**SUBDIVISION REVIEW SHEET****CASE NO.:** C8-2020-0112**COMMISSION DATE:** February 1, 2022**SUBDIVISION NAME:** Braker Valley Subdivision Preliminary Plan**ADDRESS:** 4806 Blue Goose Rd**APPLICANT:** Ranch Road Braker Valley, LLC (Daniel E. Gilpin)**AGENT:** BGE, Inc. (Chris Rawls)**ZONING:** I-SF-4A**NEIGHBORHOOD PLAN:** N/A**AREA:** 164.96 acres**LOTS:** 597**COUNTY:** Travis**DISTRICT:** 1**WATERSHED:** Walnut Creek**JURISDICTION:** Full Purpose

The request is for the approval of Braker Valley Subdivision Preliminary Plan, a 597 lot single-family subdivision on 164.96 acres.

**CITY OF AUSTIN –DEVELOPMENT SERVICES DEPARTMENT  
SUBDIVISION APPLICATION – MASTER COMMENT REPORT**

PROJECT NAME: Braker Valley Subdivision Preliminary Plan  
LOCATION: 4806 BLUE GOOSE RD

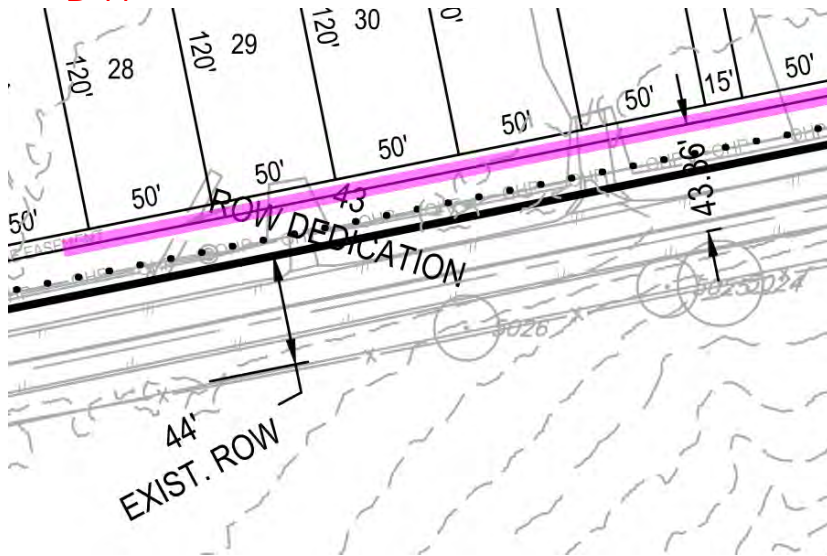
- EL 1. Please show existing overhead transmission/distribution line along Cameron Rd.
- EL 2. Please show all existing power poles and transmission structures on plat.
- EL 3. Is the additional ROW dedication moving to the highlighted line below? Please clarify additional ROW dedication.
